Barn / Guest House

Site Review Comments: 11/30/2010

West elevation in entry.

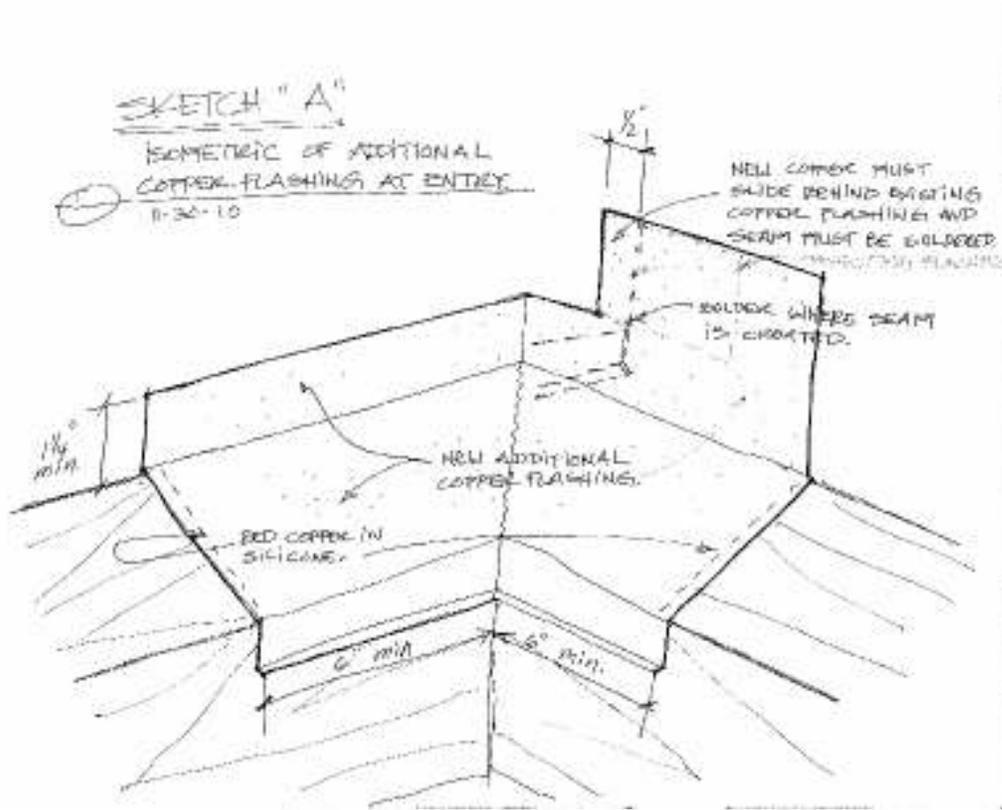
9. Please install (6) robe hooks from Emtek above the second horizontal openings in the entry. Please center the hooks in the horizontal 6 x 6.

Flashing at entry.

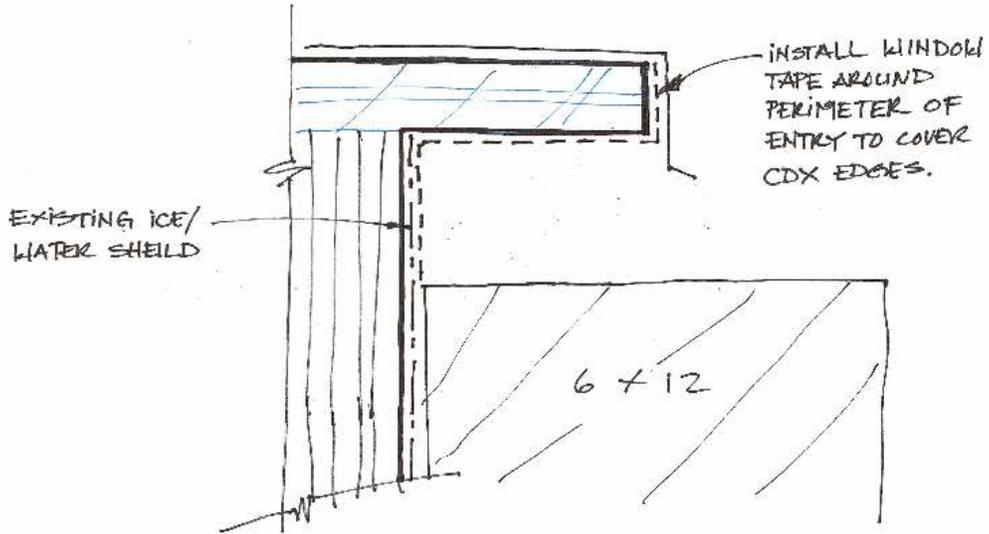
10. Please install flashing as diagrammed in Sketch "A" below on both sides of entry to seal and protect framing. Also wrap window tape over edge of concealed $\frac{3}{4}$ " CDX decking and back under bottom side to protect from moisture as diagrammed in Sketch "B".
